Access Compliance Report

Public Rights-of-Way

(Curb Ramps)

Intersection ID: N/A	Main Street: COMMUNITY_HOUSE_RD	Cross Street: N/A	Location: NW
ADA ID: C1CAD01B9B5D	Ramp Type: Perp	Initial Pass/Fail: Fail	Overall Compliance: No
Codes/Mitigation Info/Possible Solution		Field Measurements/Component Compliance	
Severity Score: 12.5

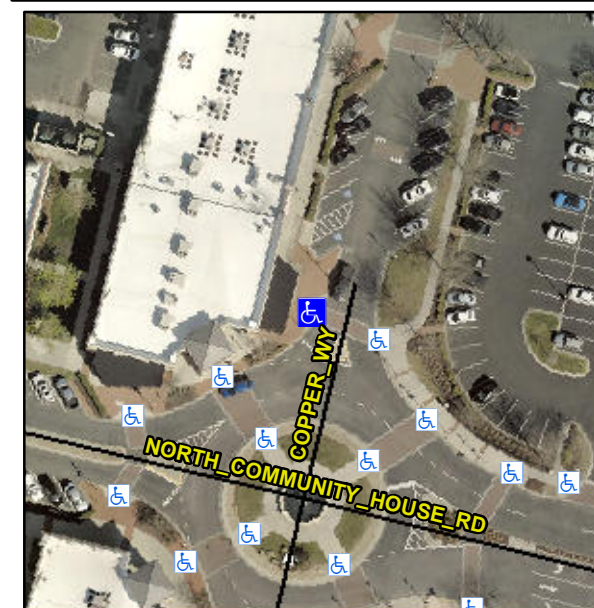
Compliance	Description	Data	Compliance	Description	Data
N/A	Ramp Length (in)	73.5	No	Ramp Slope (%)	9.5
Yes	Ramp Width (in)	118.0	Yes	Ramp XSlope (%)	0.9
N/A	Flare Type LT	N/A	N/A	Flare Type RT	N/A
N/A	Flare Slope LT (%)	N/A	N/A	Flare Slope RT (%)	N/A
N/A	Flare Traversable LT?	N/A	N/A	Flare Traversable RT?	N/A
N/A	Landing Length (in)	N/A	N/A	DWS Provided?	N/A
N/A	Landing Width (in)	N/A	N/A	DWS Contrast?	N/A
N/A	Landing Slope (%)	N/A	N/A	DWS Length (in)	N/A
N/A	Landing X Slope (%)	N/A	N/A	DWS Full Width?	N/A
N/A	Landing Curb? (Y/N)	N/A	N/A	DWS Offset (in)	N/A
N/A	Shared Landing?	N/A			
N/A	Gutter Ponding?	N/A	N/A	Gutter Slope (%)	N/A
N/A	Gutter Lip Ht (in)	N/A	N/A	Gutter X Slope (%)	N/A
N/A	Painted X Walk1?	Yes	N/A	Painted X Walk2?	N/A
	X Walk 1 Direction	To SE		X Walk 2 Direction	N/A
N/A	X Walk 1 Width (in)	94.0	N/A	X Walk 2 Width (in)	N/A
	X Walk 1 Slope (%)	0.1		X Walk 2 Slope (%)	N/A
	X Walk 1 X Slope (%)	2.3		X Walk 2 X Slope (%)	N/A

Remove & Replace Entire Ramp.

R304.2.2
